Narrative: Proposed renovation, improvements, demolition, and additions to Historic Building

Address: 492 S Convent Ave
Tucson AZ 85705

These are drawings (existing conditions on left, proposed on right) presented in the review on 4/11/2022 and identified in the motion to continue, these items were identified as needing further review and modification:

Changes made and new proposed design:

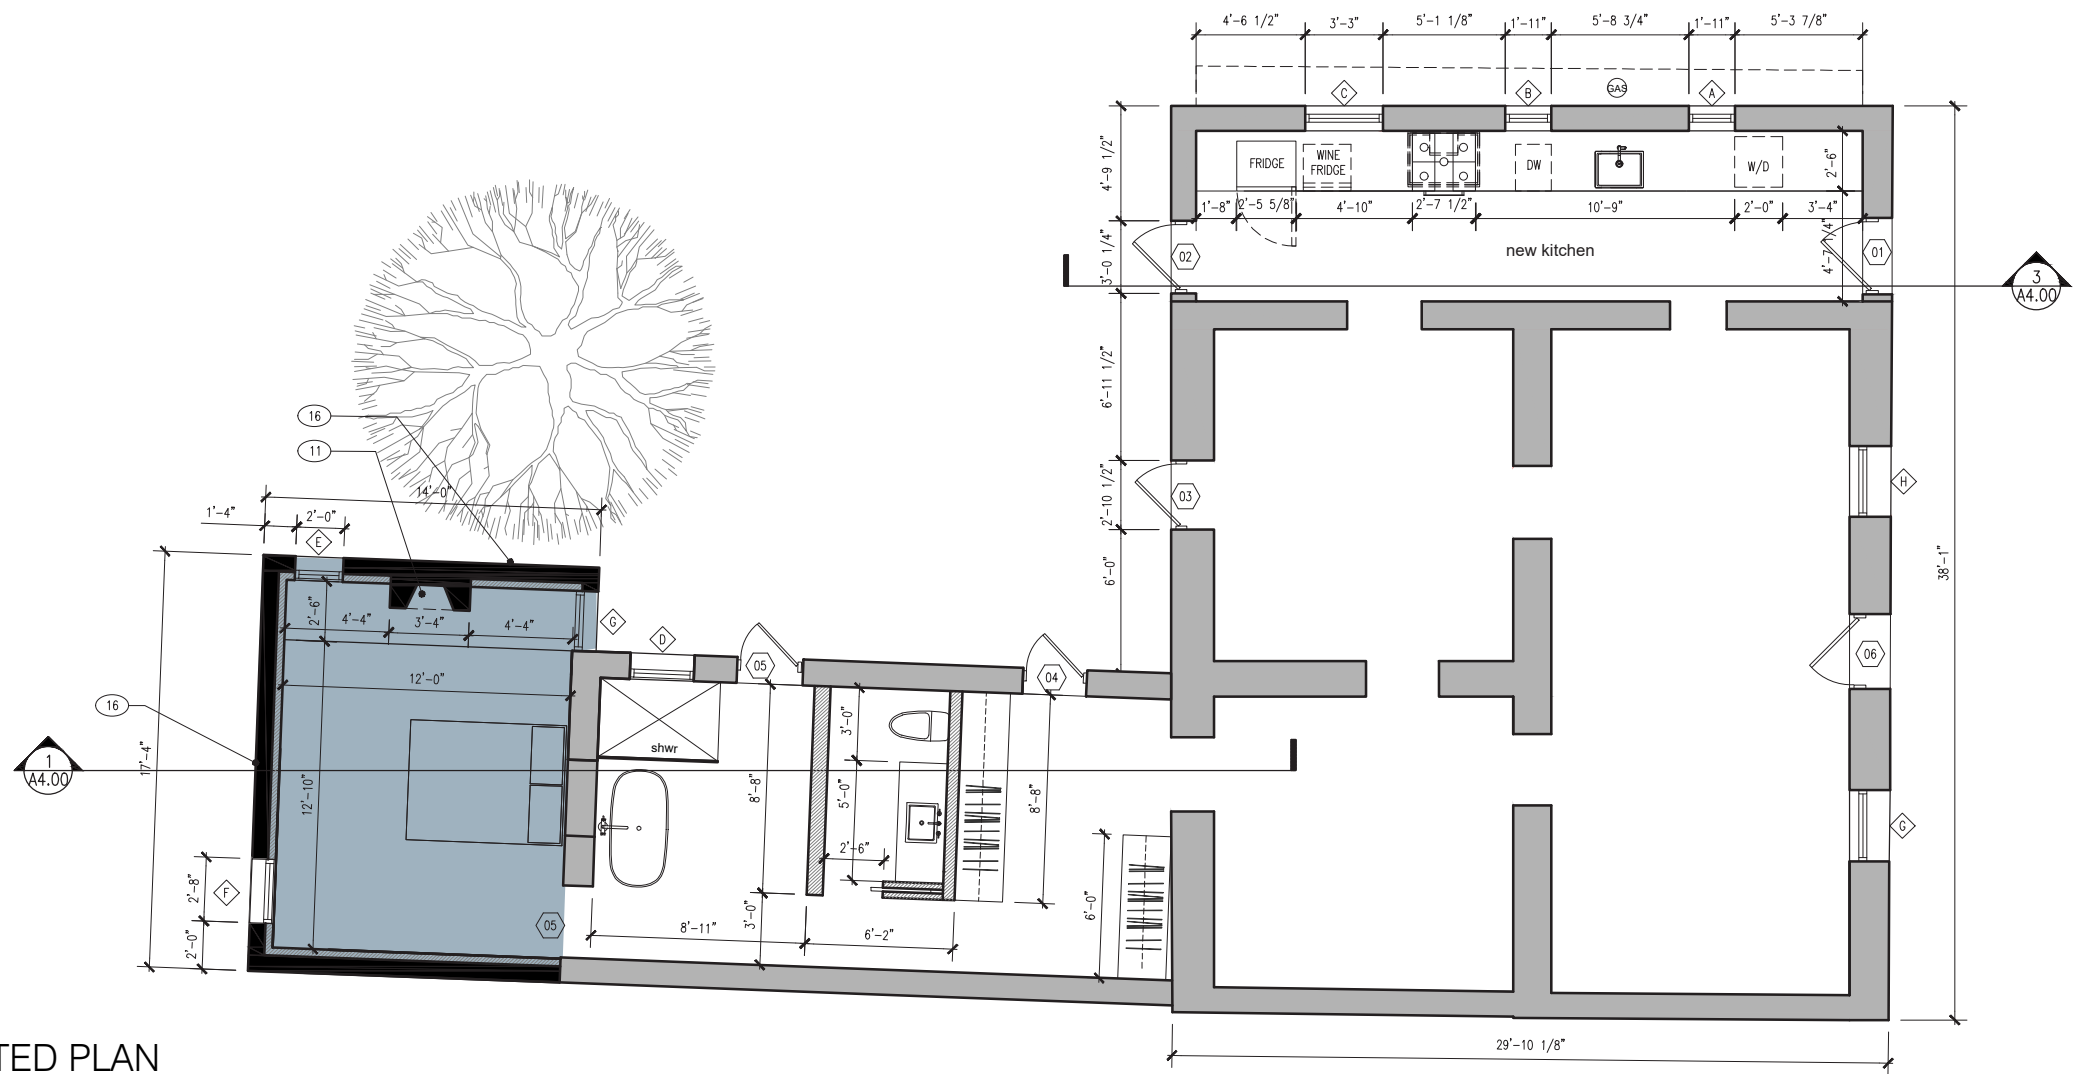
1. **Distinction between old and new** - The proposed idea on 4/11 kept the CMU addition at the same height, surface plane, and surface texture and color. We were asked to revisit this composition.
2. **Window proportions** on the existing North add-on that is to become the kitchen needs revisiting. The proposal to reportion the window opening to suit the function on the interior was an issue.
3. **Fireplace** wasn't formally motioned for continuation, but we took this into consideration in the new proposed scheme

UPDATED PLAN

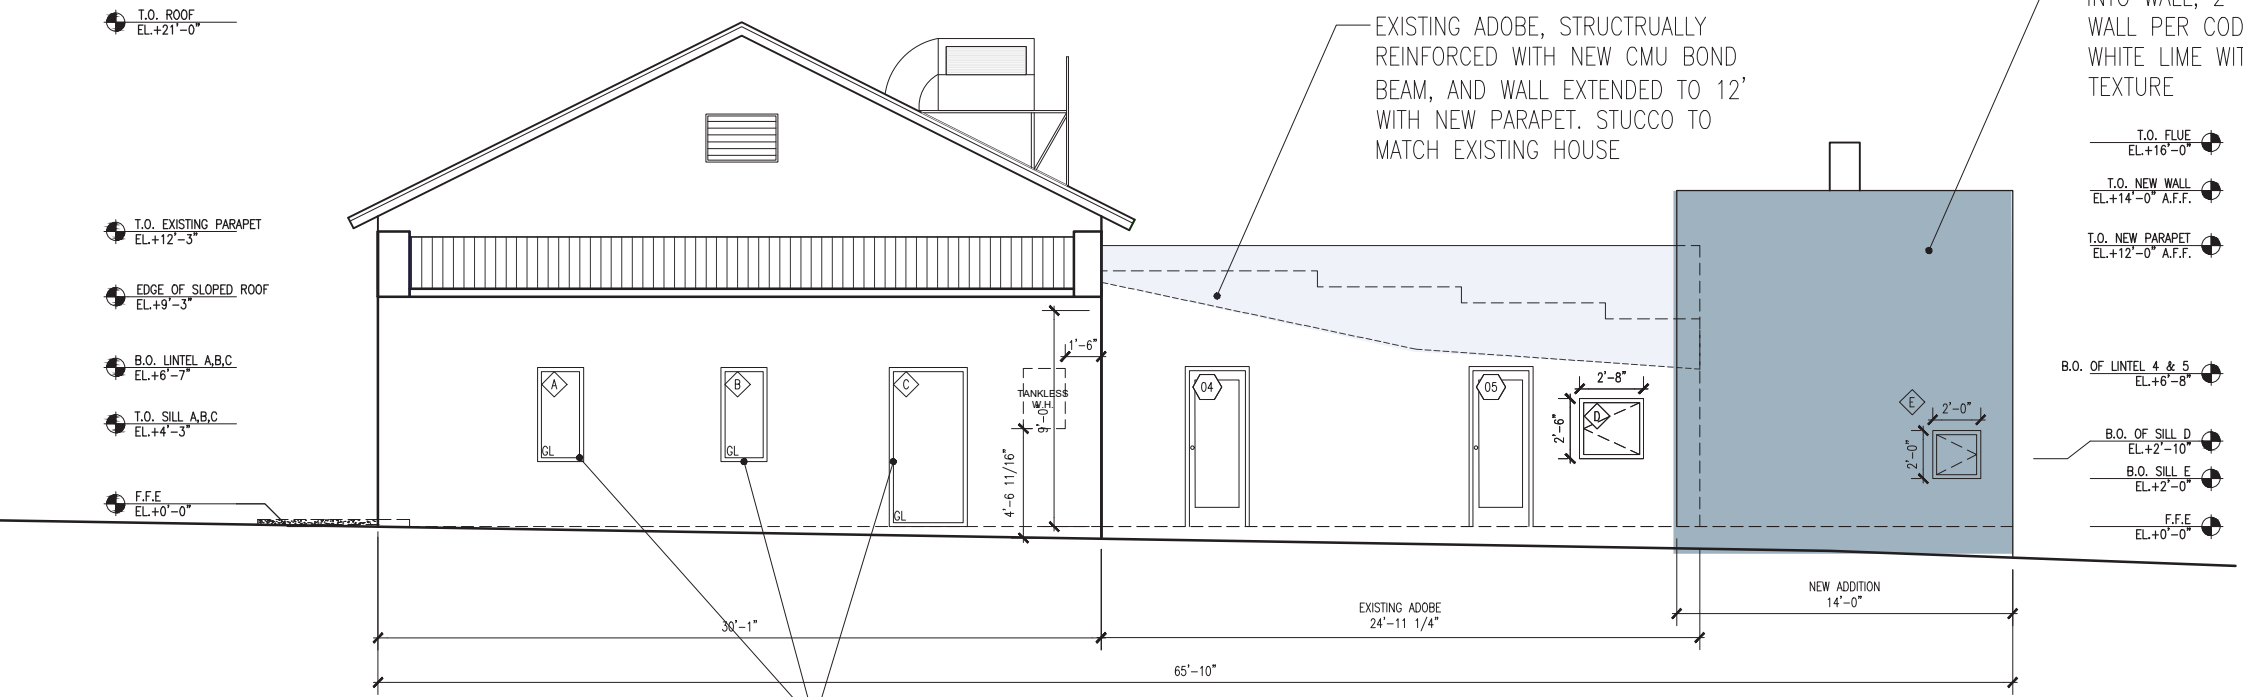
1. **Distinction between old and new** - The existing adobe is reinforced with a cmu bond beam and added parapet. We are specifying the finish stucco to match the existing house (smooth white lime stucco) and adobe construction for a weather-tight, seamless transition between the CMU structural reinforcement and the existing adobe wall below. The color, texture, to refer to what is original on the property. Door and Window openings to remain original, but to be outfitted with new wood frames/glass.

The new CMU addition is enlarged to formally express the distinction between new and old, both in plan and elevation. Added 81 sq ft from prior proposal. The wall height is up to 14', lower than the neighbors 16' wall to the south, and just taller than the 13' tall wall to the north, both on the property line. (see diagram on p.4)

2. **Window Proportions** on existing north add-on wall to remain unchanged, Finish Carpentry details will resolve the space on the interior.

3. Fireplace is absorbed in the wall and only the flue protrudes 2' above the wall, per code.

Diagram of existing windows and new kitchen

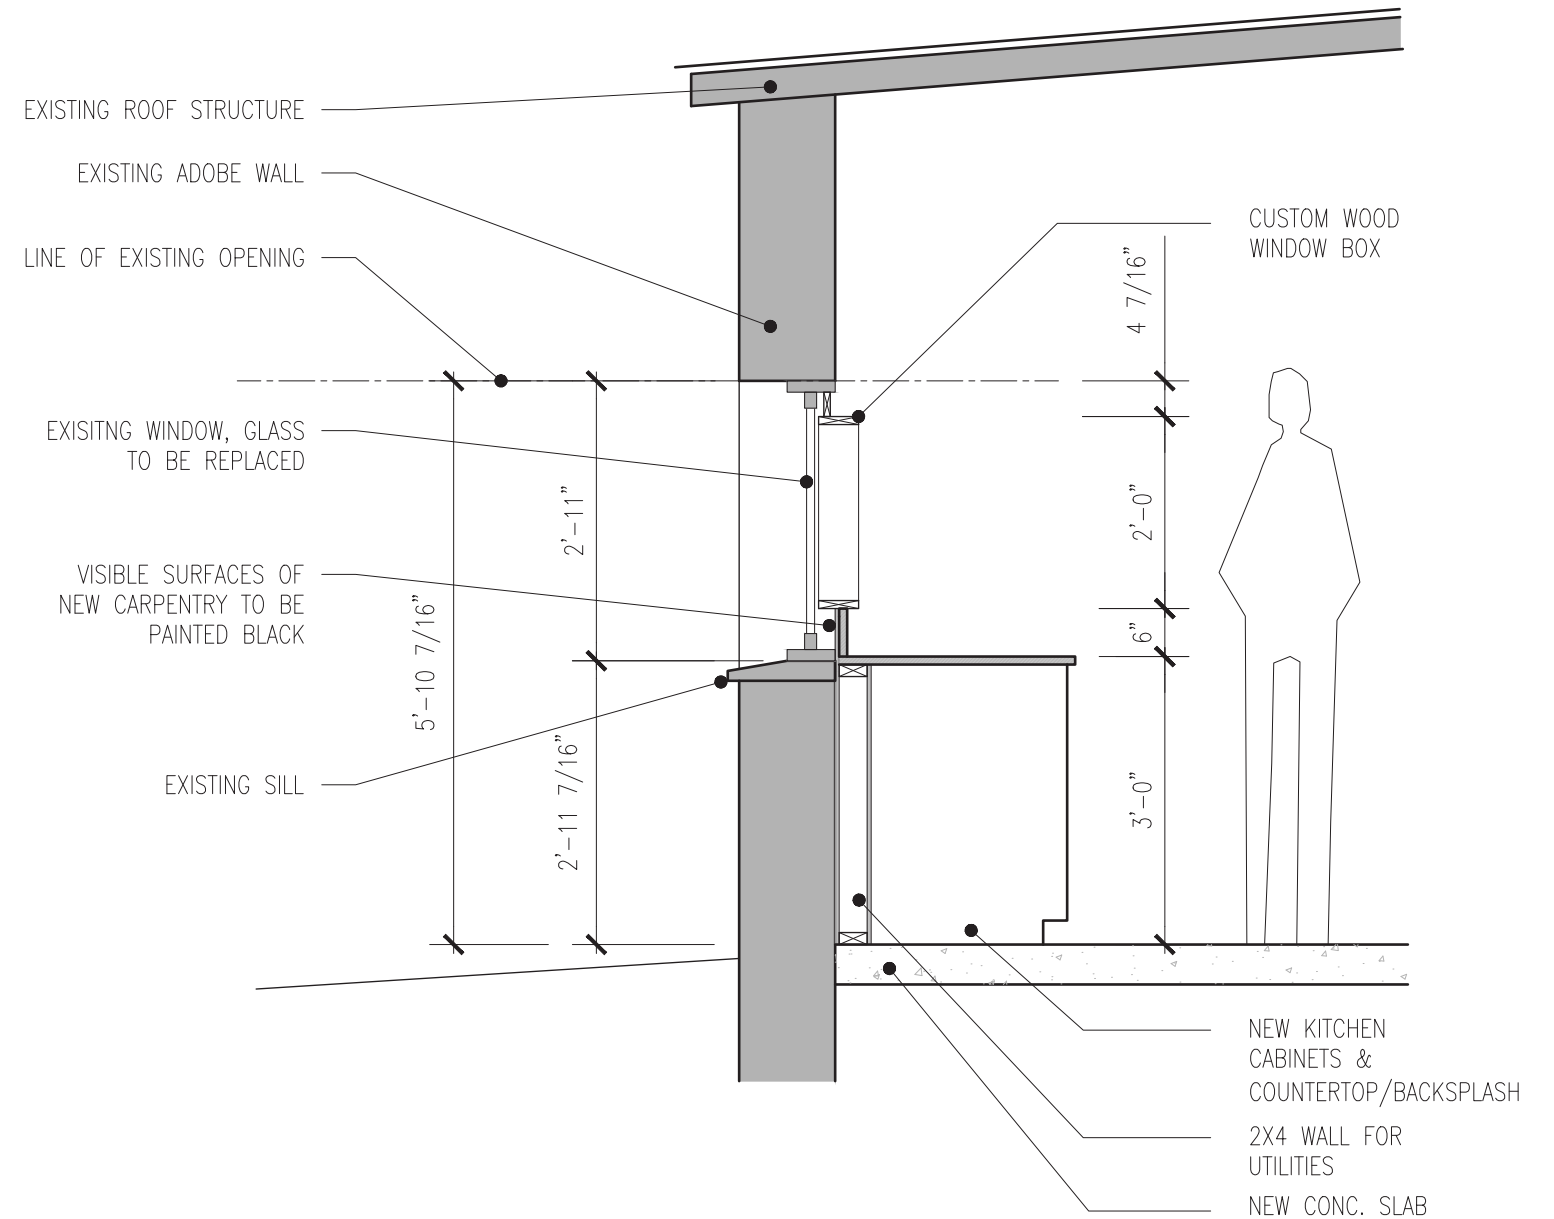
- Leaving the existing opening and frame untouched. Replacing glass
- Visible Carpentry on interior to be painted black
- Wood Window box on interior to frame glass
